WARRANTY BULLETIN

Wb03-19

SUBJECT VERIFICATION OF TIGHTENING TORQUE ON
18000LBS INDEPENDENT SUSPENSION LOWER

A-ARM

FIGURE 1

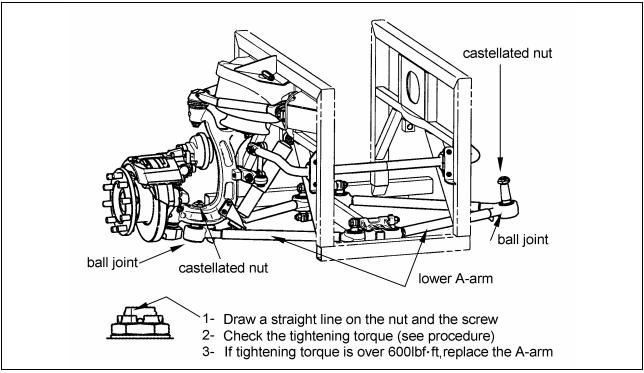
- 1. Raise the vehicle. Remove the front wheels.
- 2. Locate the castellated nut (see figure 1). Remove the cotter pin.
- 3. As a reference mark, draw a straight line on the nut and the screw (figure 1). This mark will indicate if the nut has turned during the test.

Note: The maximum admitted tightening torque is 600lbfat. It is necessary to check if the present tightening torque is under 600lbfat. To do so, use a torque setting type torque wrench (automatic cut-out) adjusted to 600lbfat. The goal is to check if the castellated nut turns during application of a torque, while avoiding triggering off of the torque wrench. The reference line on the nut and screw will help to detect a small rotation. Apply a torque clockwise, which is the normal direction to tighten the nut. **While tightening, do not pass the cotter pin insertion hole in order to avoid increasing the torque higher than 600lbfat.**

If the nut rotates and there is no triggering off of the torque wrench, then the castellated nut is not tighten to high, the A-arm doesn't have to be replaced. If there is triggering off of the torque wrench with no rotation of the castellated nut, then the nut is tighten to high.

- 4. Check the tightening torque.
- 5. If the tightening torque is less than 600lbf oft, no replacement is required and part B of this bulletin doesn't have to be performed. Just place a new cotter pin #502106. If the castellated nut has been tightened to high, the lower A-arm has to be replaced as described in **part B**.

FIGURE 2

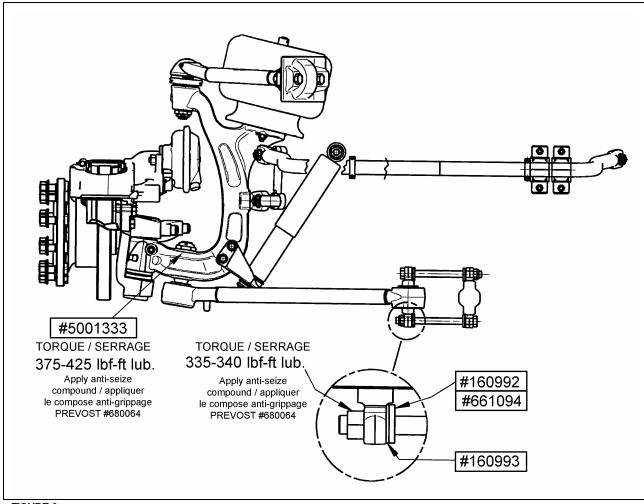
- 2. Adequately support the axle.
- 3. Remove the lower A-arm. Discard the A-arm, the castellated nut and the cotter pin. Keep the other parts for later use.
- 4. Install the new A-arm as shown in figure 2. Use a new castellated nut #5001333 and a new cotter pin #502106. Tighten to a torque of 375lbf⁴t then turn the nut just to be able to insert the cotter pin. Assure that the torque is not higher than 600lbf⁴t. Apply anti-seize compound #680064 on threads.

Note: After replacement of the A-arm, it is necessary to readjust the front wheel alignment. See Front End Alignment in your Maintenance Manuel section 16.

5. Proceed to the wheel alignment. Use the shims and if necessary, get extra shims listed above.
